UNITED STATES PATENT AND TRADEMARK OFFICE

10/749,085

Jacob H. Morelissen

Office Action Summary	Application No.	Applicant(s)	
	10/749,085	MORELISSEN ET AL.	
	Examiner	Art Unit	
	Yvonne M. Horton	3635

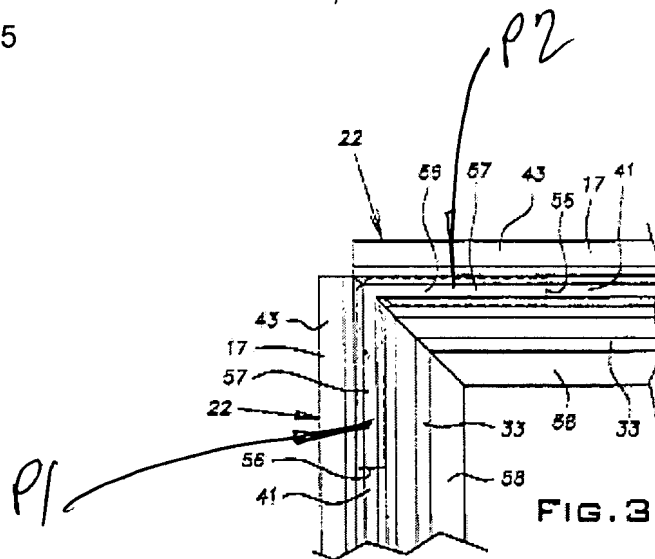
Claims 1-9,13,14,16-19,21-24,28,29,31 and 32 are rejected under 35 U.S.C. 103(a) as being unpatentable over US Patent #6,499,262 to PINCHOT et al. in view of US Patent #5,644,872 to PERDUE.

In reference to claim 1, PINCHOT et al. discloses a ceiling panel (12) having a main frame (17), at least two crossing members (57) that crosses the main frame (17) at two points (P1,P2) and aids in bridging the veil indirectly therewith, and a veil facing material (18) adhered to the main frame (17), column 4, lines 57-60. PINCHOT et al. discloses the basic claimed ceiling PINCHOT et al. discloses the basic claimed ceiling

panel except for specifically forming the ceiling panel facing from a glass fiber material. PERDUE teaches that it is known in the art to form a ceiling panel having a glass fibrous fabric facing (14). Hence it would have been obvious to one having ordinary skill in the art at the time the invention was made to form the panel of PINCHOT et al. with the glass fibrous facing material of PERDUE in order to create a ceiling panel that is not only pleasantly appealing, but that is also porous and that also has sound dampening properties and that is not flammable. Further, the applicant has disclosed and claimed the material of his facing as being made from several different materials such as veil, textile, fabric, polymeric film, foils, etc. Thus, the applicant has shown no criticality for the selection of one material over the other. Hence, it would have also been obvious to one having ordinary skill in the art at the time the invention was made to select a known material on the basis of its suitability for the use intended as an obvious matter of design choice. In reference to claim 2, the main frame (17) and crossing members (57), once joined together are one-piece. The applicant is reminded that in apparatus claims, it is the final product that is given patentable weight. Regarding claims 3,6,7 the main

frame (17) and the crossing members (57) are extruded, flame retardant, polyvinyl-chloride plastic, column 2, lines 47-51. In reference to claims 4,8,9, the applicant has shown no criticality in the type of material used to form the frame and crossing members, thus it would have been obvious to one having ordinary skill in the art at the time the invention was made to select a known material suitable for the use intended as an obvious matter of design choice. Regarding claim 5, the method of forming a device is not germane to the issue of patentability of the device itself. In reference to claim 13, the facing material (18) is adhered to the main frame (17) by an adhesive, column 4, lines 57-60. Regarding claim 14, the main frame (17) is square. In reference to claim 16, PINCHOT et al. discloses the method of making a ceiling panel (12) including the steps of providing a main frame (17), providing first and second crossing members (57) that cross the main frame (17) at two points (P1,P2), providing a facing material (18), affixing the facing member (18) to the main frame (17) and the crossing members (57). Regarding claims 17 and 20, the applicant details the main frame and crossing members are one piece, but also details the main frame and crossing members as being welded together. Thus, the applicant has shown no criticality in how the main frame and the crossing members are attached, and as such, any suitable manner of forming the main frame and the crossing members would be suitable for the use intended as an obvious matter of design choice. In reference to claims 18,21,22 the main frame (17) and the crossing members (57) are extruded, flame retardant, polyvinyl-chloride plastic, column 2, lines 47-51. In reference to claims 19,23,24, the applicant has shown no criticality in the type of material used to form the frame and

crossing members, thus it would have been obvious to one having ordinary skill in the art at the time the invention was made to select a known material suitable for the use intended as an obvious matter of design choice. In reference to claim 28, the facing material (18) is adhered to the main frame (17) by an adhesive, column 4, lines 57-60. Regarding claim 29, the main frame (17) is square. In reference to claims 31 and 32, the facing (18) underlies and is provided to underlie the main frame (17).
